DETEX CORPORATION
 SHO MISAWA
 PHONE: 800-729-3839 EXT.4377
 PCB: 106015
 PWA: 106016

DETEX CORPORATION
 SHO MISAWA
 PHONE: 800-729-3839 EXT.4377
 PCB: 106015
 PWA: 106016

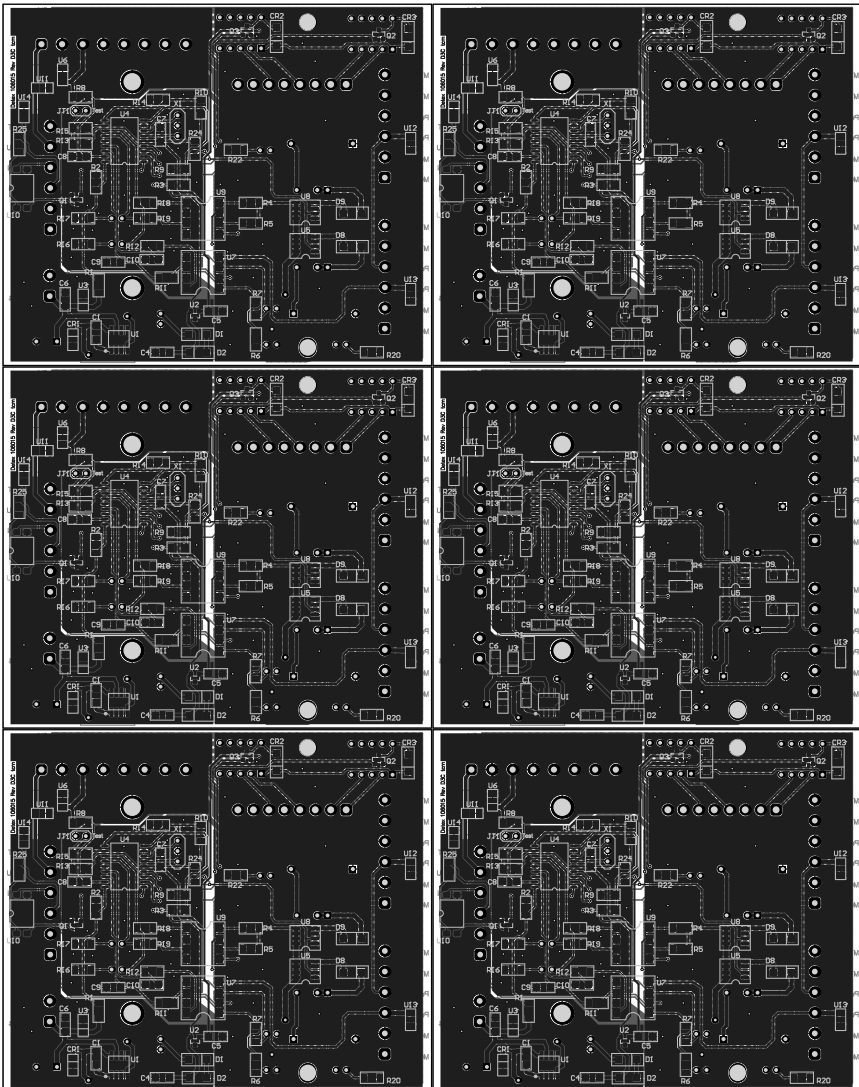
- 106015 Rev A: Incorporate design from 103845 and 104280 Dual Door PWA's.
 Add teltale LED's, replace relay with two PG511's. Ass opto isolators for Status LED's, Pad and Cyl switches. Route all I/O functions onto main connectors to simplify wiring.

- Rev B: Replace .156 spacing connectors with 3.81mm metric connectors. Fix logic erros on Cyl/Pad opto, add pullup to high side switch
- Rev C: Replace 3.81 connectors with separate .200" connectors for each function
 Retain 3.81 for relay connections for space. clean up power trace routes

- Rev D: Add opto for siren drive/isolation.
- Rev D3: Add TVS to Pad and Cyl inputs. Redo gnd planes for better EML. Released to proto 06/16/15
- Rev D3A: Increase mounting hole tolerance. Make one snap mount oval for REM stud variation.

- Rev D3B: Add U14 TVS to 9 volt source for ESD issues.
 11.12.2018
- Rev D3C: Fixed unconnected ground pad on regulator due to imported design rules.
